Access Compliance Report Public Rights-of-Way (Curb Ramps)

Main Street: SIENNA_PKWY		Cross Street: O_NEILL_DR		Location:	NE
ADA ID: RPRK211111130740	Ramp Type: Type 1 - Perpendicular	Initial Pass/Fail: Pass	Overall Compliance: No	Severity Score:	0
Codes/Mitigation Info/Possible Solution			Field Measurements/Component Compliance

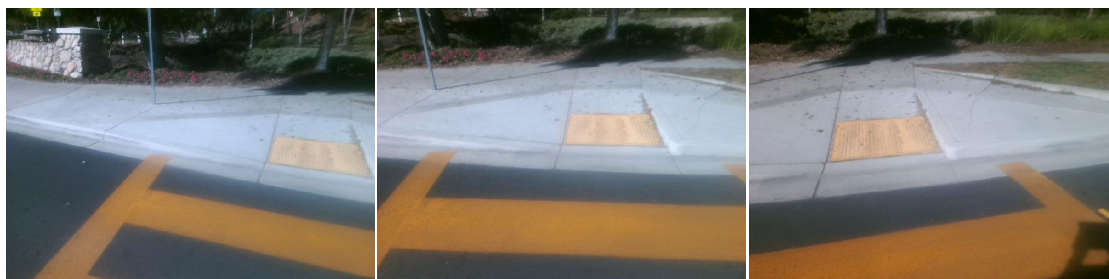
R304.2.2, R304.2.3, STD 1115

Remove & Replace Entire Ramp.
